WORCESTER COUNTY PLANNING COMMISSION AGENDA

III. Major Site Plan Review - Woodside Solar Project – 5589 Woodside Lane

IV. Major Site Plan Review – Snow Solar Project – 6413 Timmons Road

Re: Woodside Solar Comment Package Response
Letter
Woodside Solar Project
5589 Worcester Hwy,
Snow Hill, MD 21863

C-SP-2.0

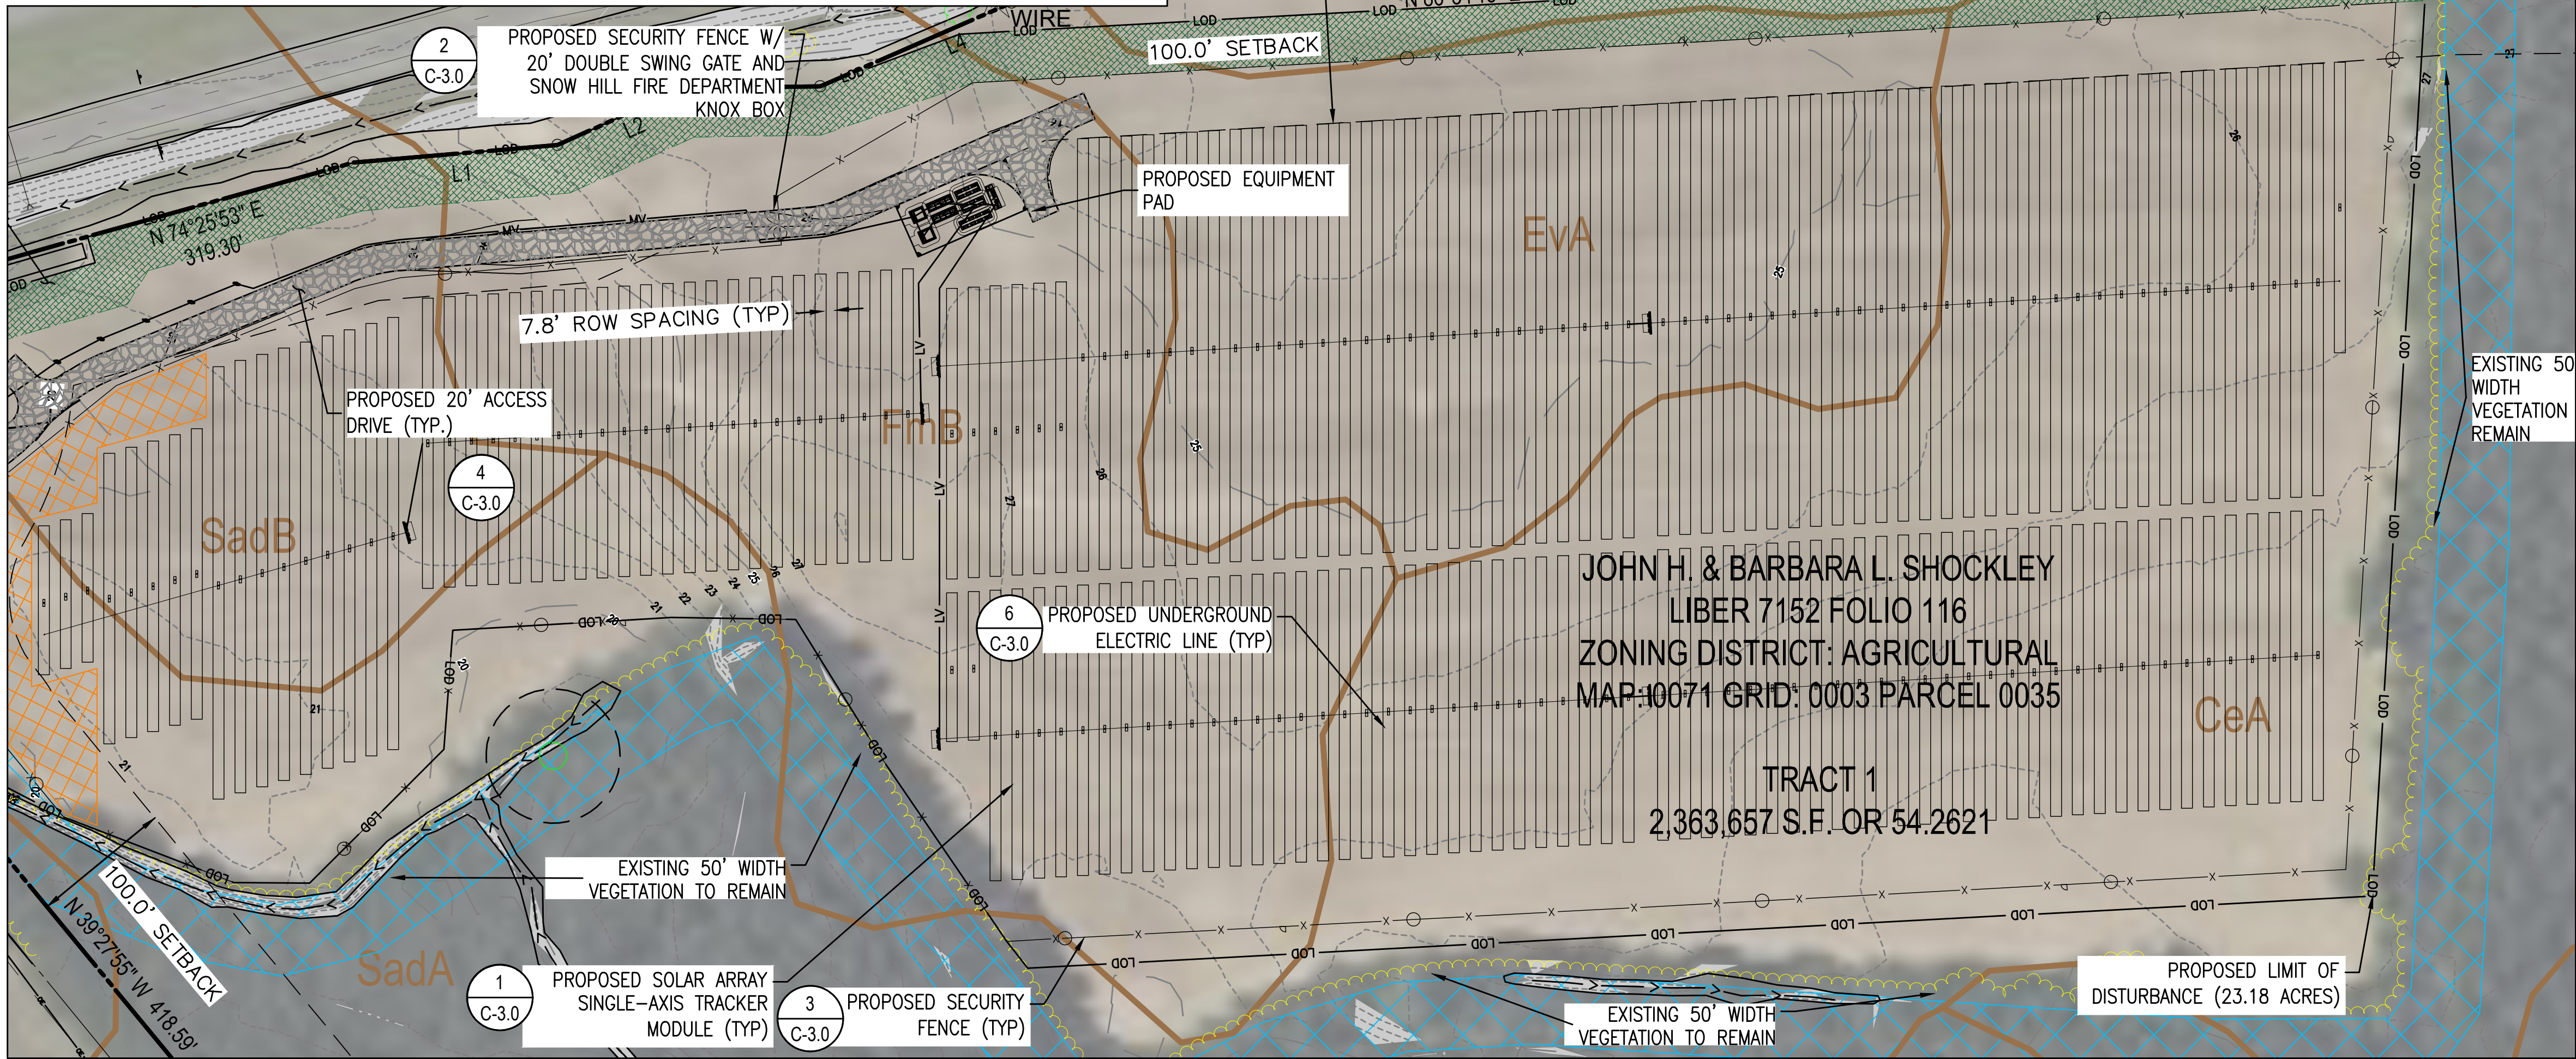
Comment 3: Sheet C-SP-2.0: Please clarify that no topsoil shall be removed from the parcel, although it can be moved or temporarily stockpiled for grading. Public Utilities Article 7-218(f)(5)(i)-(v).

Response: Note 25 has been added to sheet C-SP-2.0 that clarifies this.

C-SP-3.0

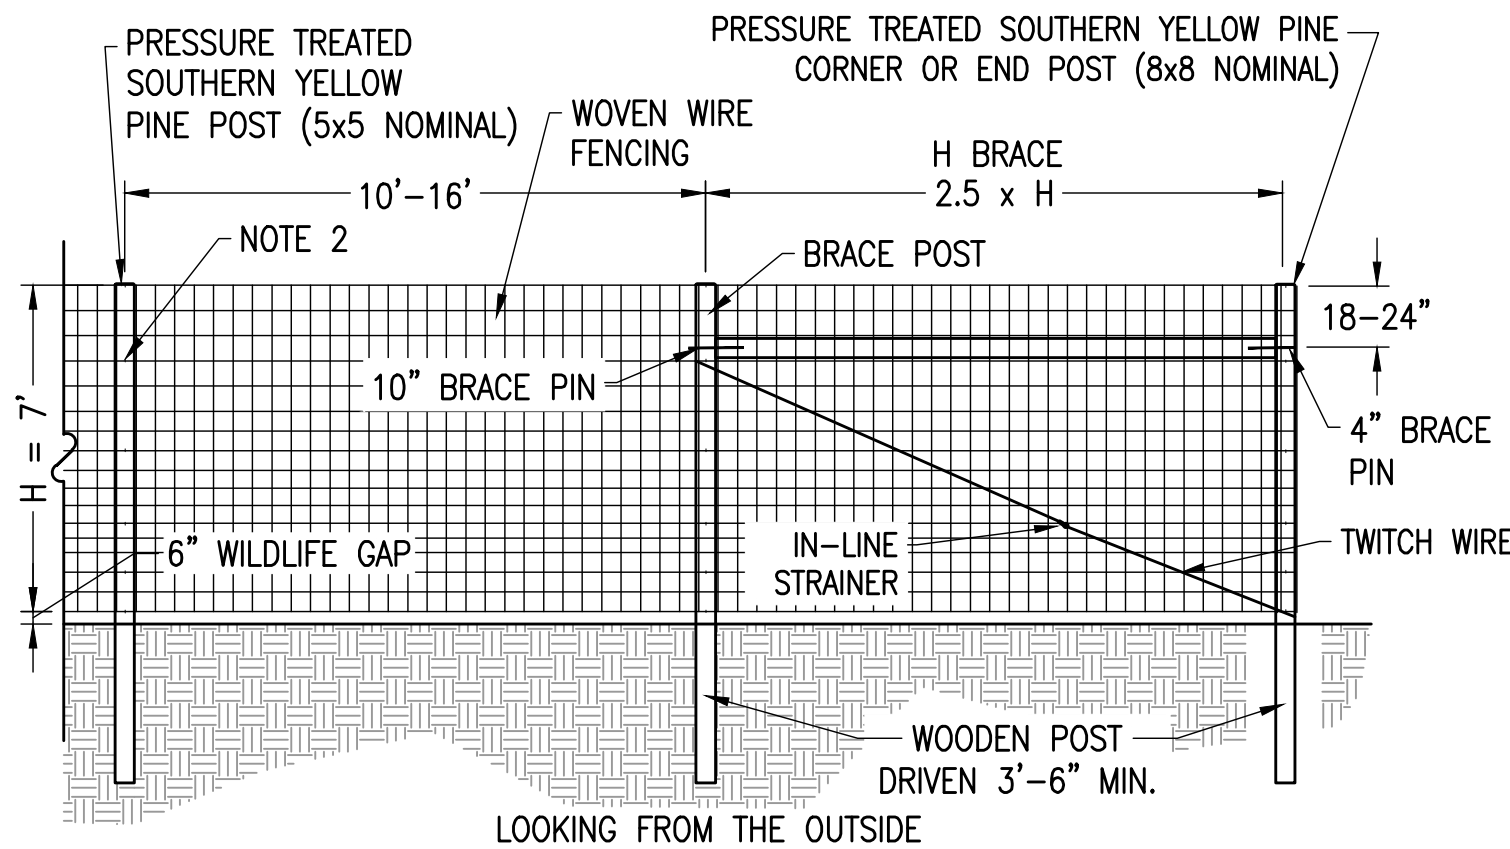
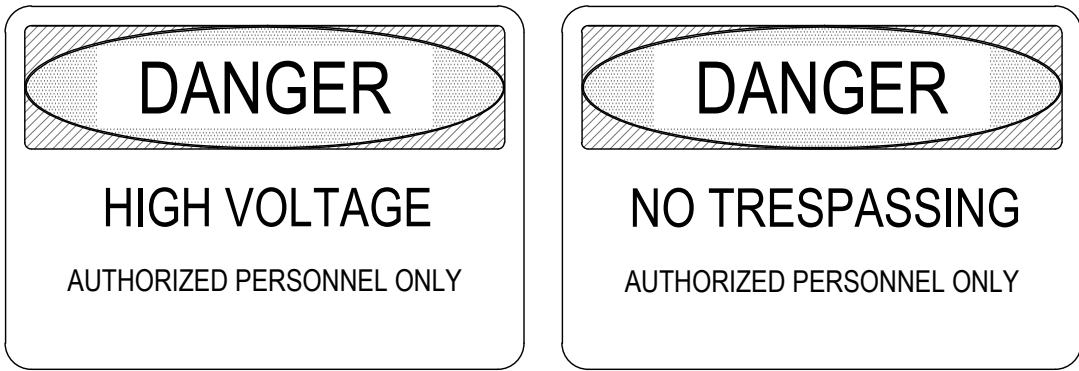
Comment 1: Please show the signage that is shown on typical detail #7 on sheet C-SP-3.0.

Response: This signage has been added to the proposed conditions sheet, spaced at 250' as detailed on sheet C-SP-3.0.

C-4.0

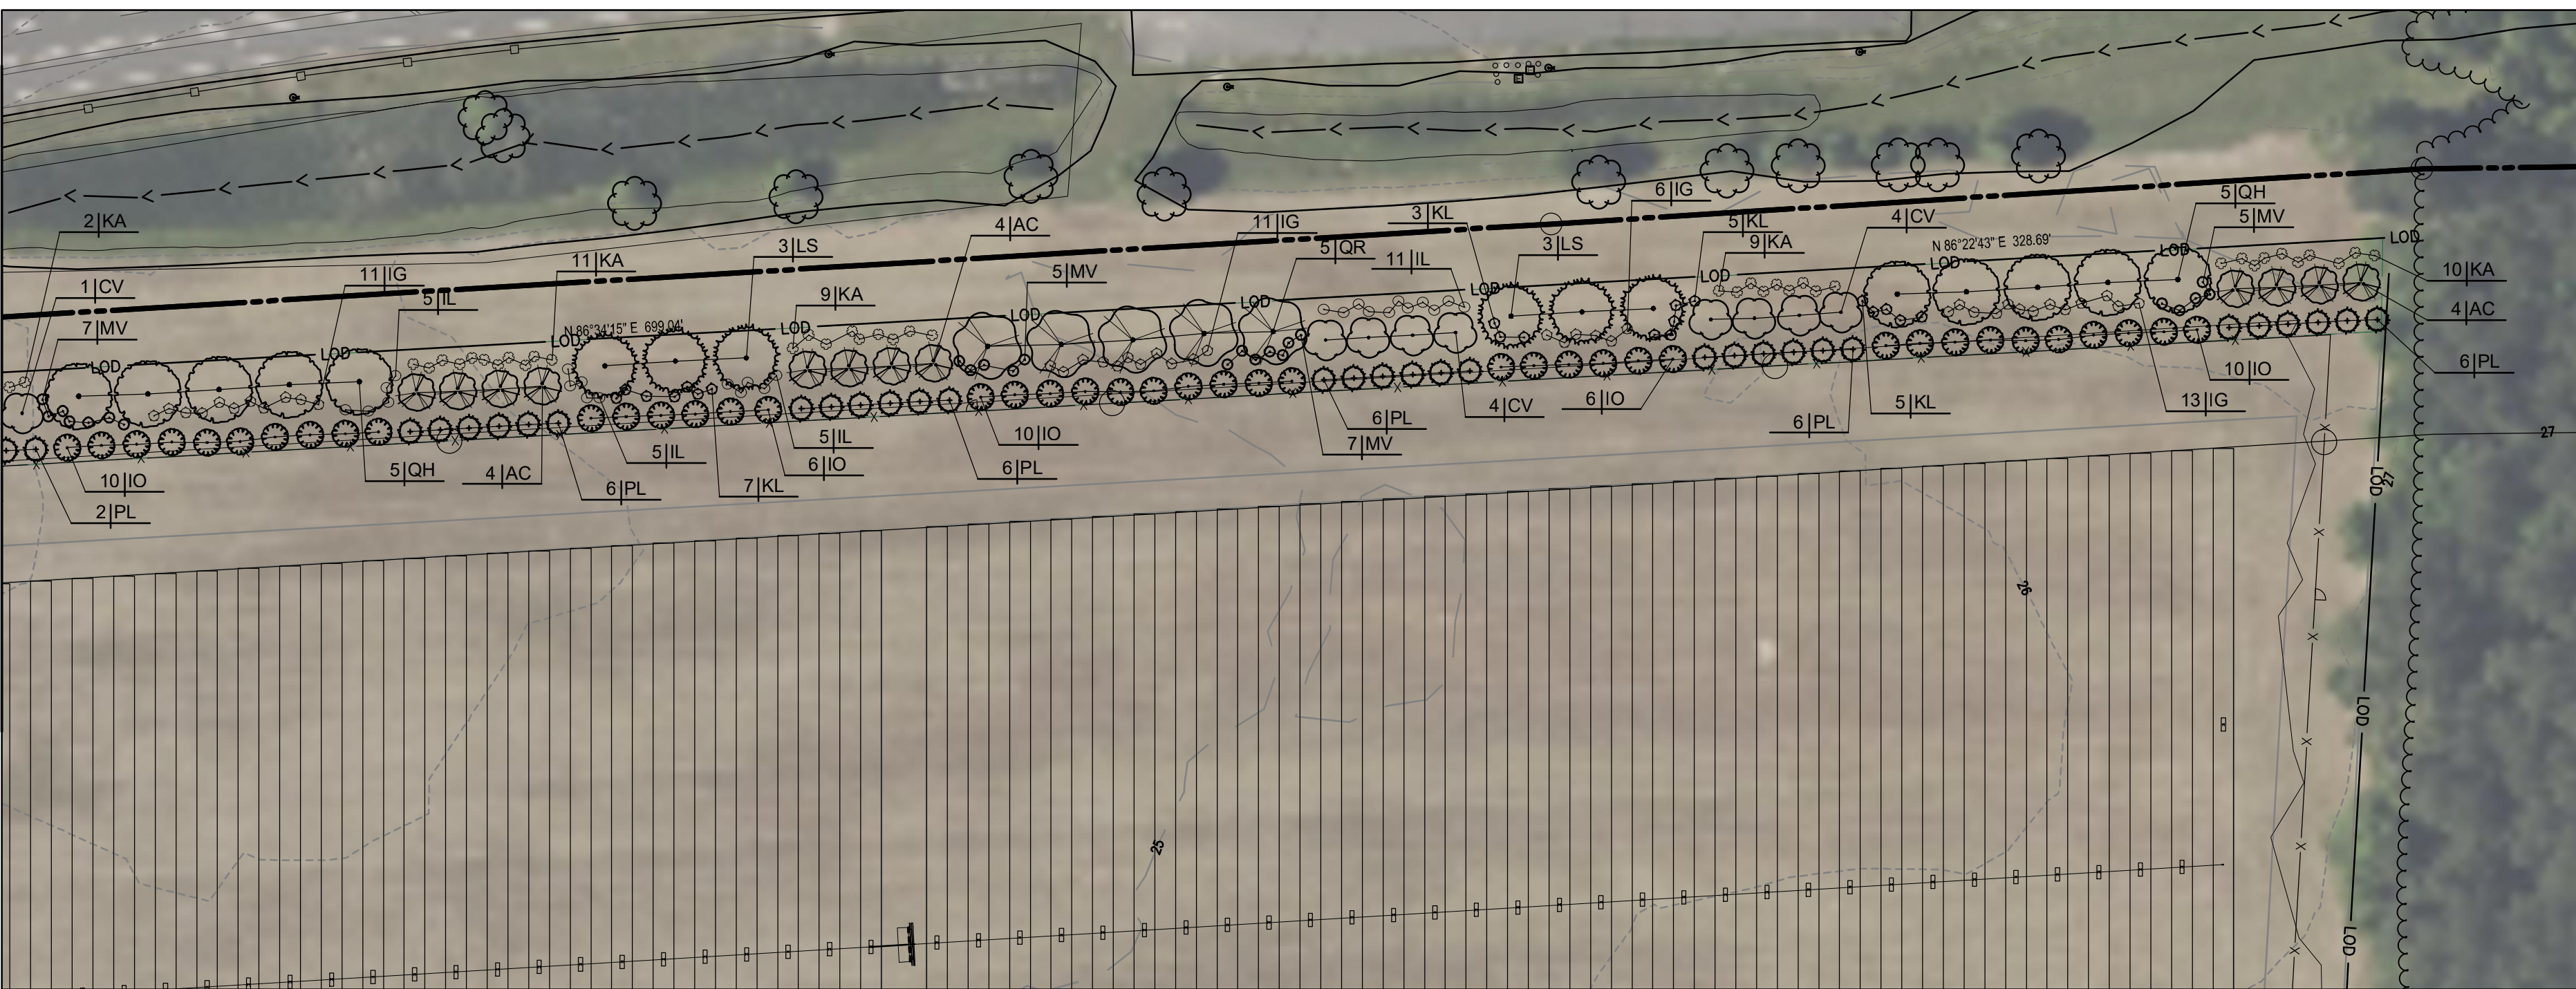
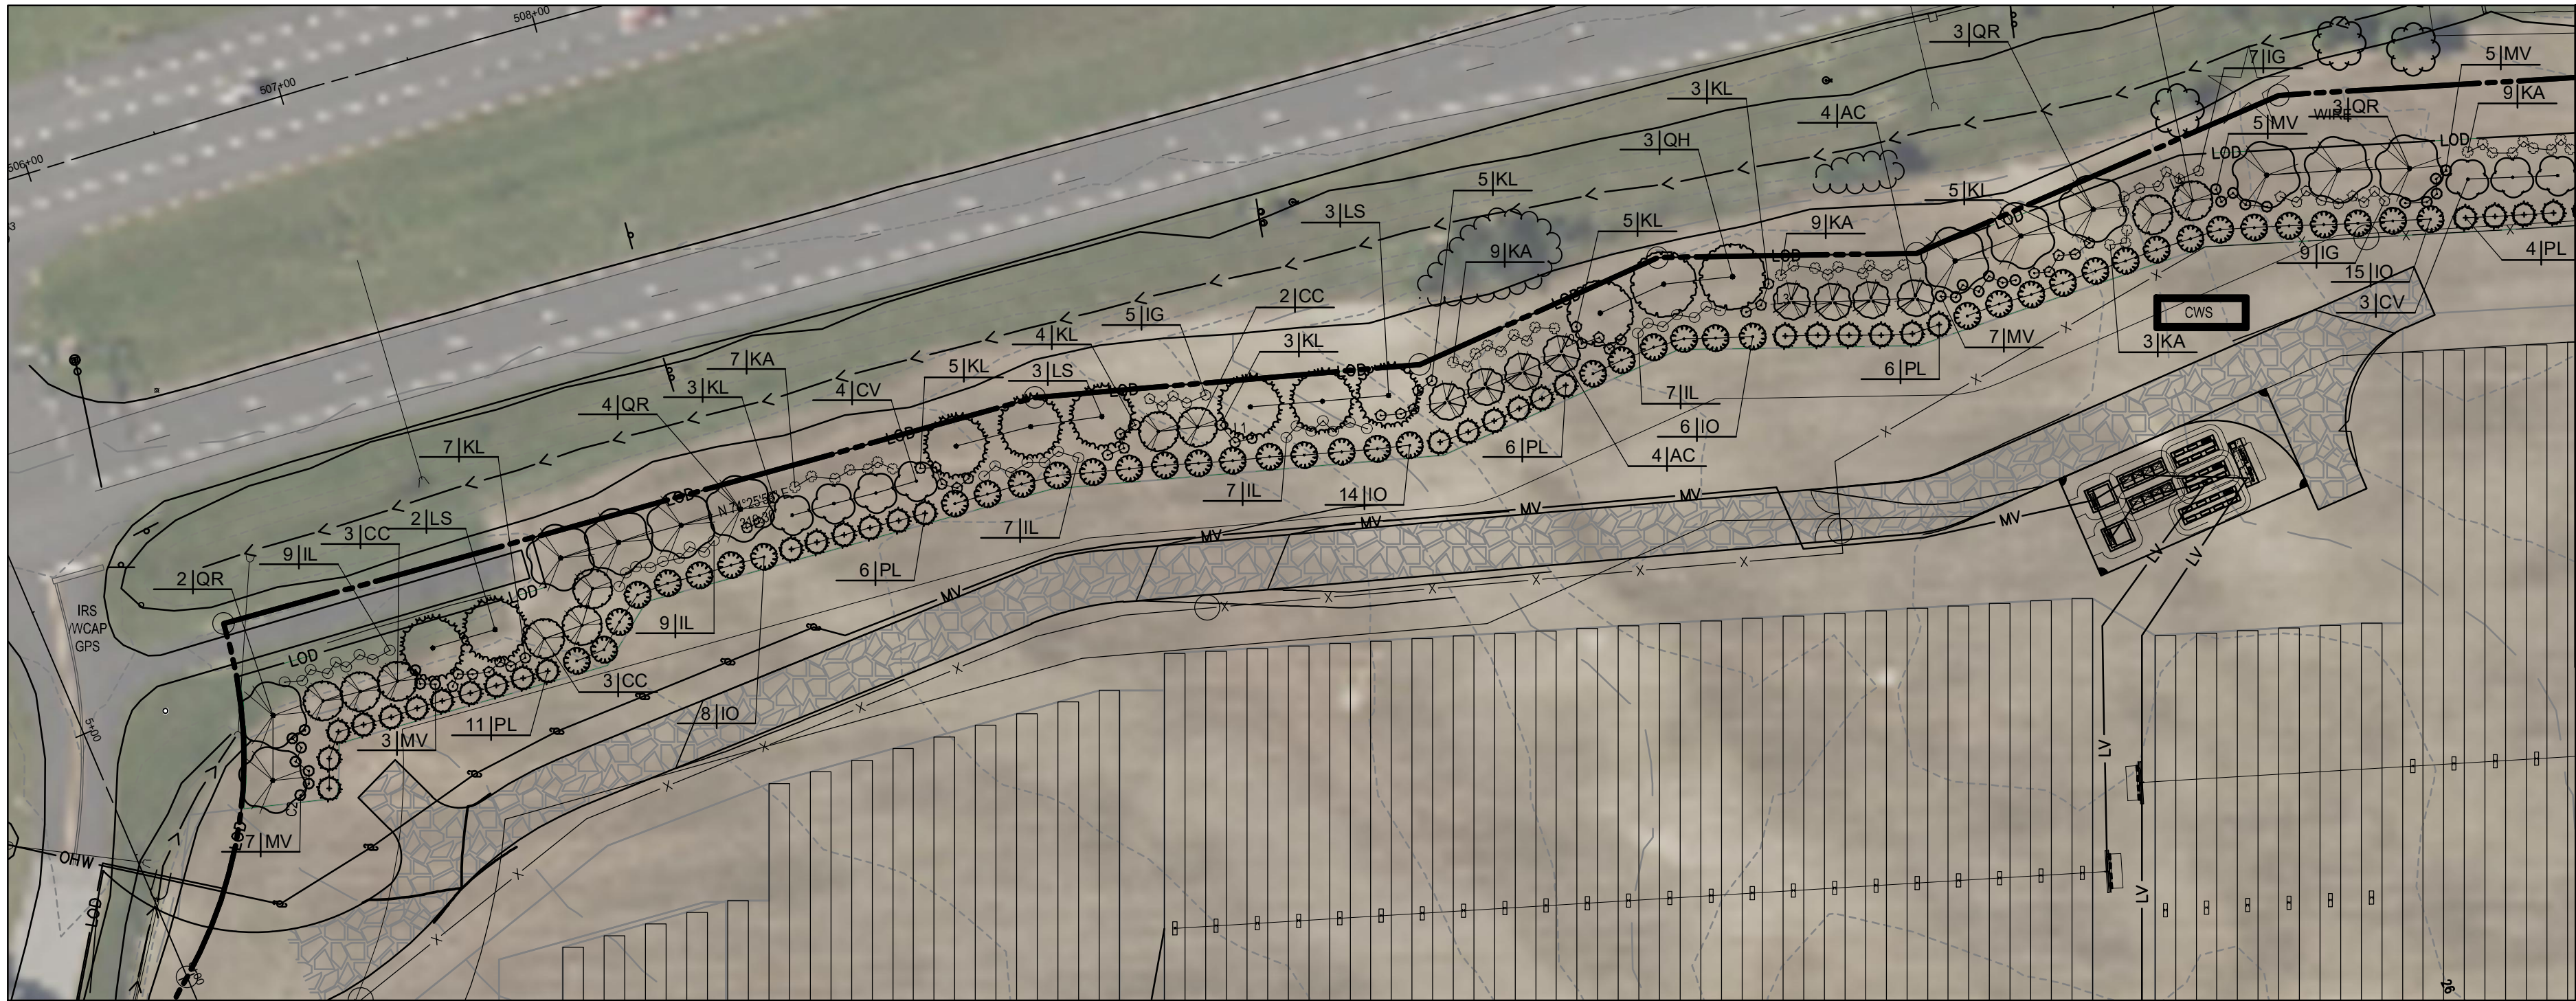
Comment 4: Sheet C4.0: Within General Notes, Note C, please also add that substitutions shall not be made without Worcester County approval.

Comment 5: Sheet C4.0: Please specify the landscaping maintenance system or watering plan. Per County code: "Each landscaped area must be readily accessible to a water supply. Unless xeriscaping plant material and technologies are employed, all landscaped areas shall provide an automatic irrigation system with rain sensors. Drip irrigation systems are preferred. If an automatic system is not feasible, the Planning Commission at its discretion may approve an alternate watering system to maintain the plant material." §ZS1-322(b)(7).

Response: This note has been added to Sheet C-4.0.

Response: This information has been added to Sheet C-4.0 as General Note 4.
